## **Addendum for RFB 0917335037**

Project Name: IVH – 2017 Roadway Improvements & Utility Tunnel Repair

Date: 06/28/2017

Addendum #02:

## CP1B401

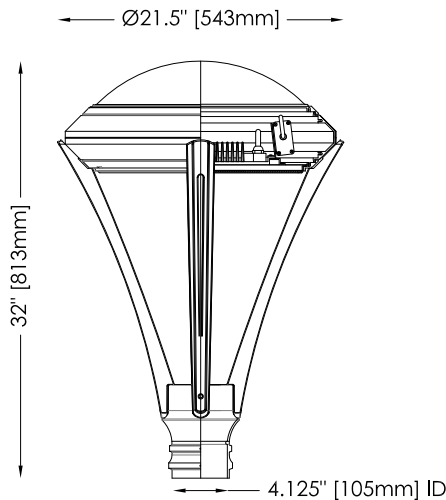
- It shall be the responsibility of the contractor to procure services for construction surveying throughout the project. A revised bid form will be incorporated with this addendum to include construction surveying.
- LUMCA Inc. has been approved as a manufacturer for the light poles and fixtures. See attached substitution request.
- Q – How long must the concrete top cure prior to applying the waterproofing sealant?

Proposed Substitution:

Differences between proposed substitution and specified product: None
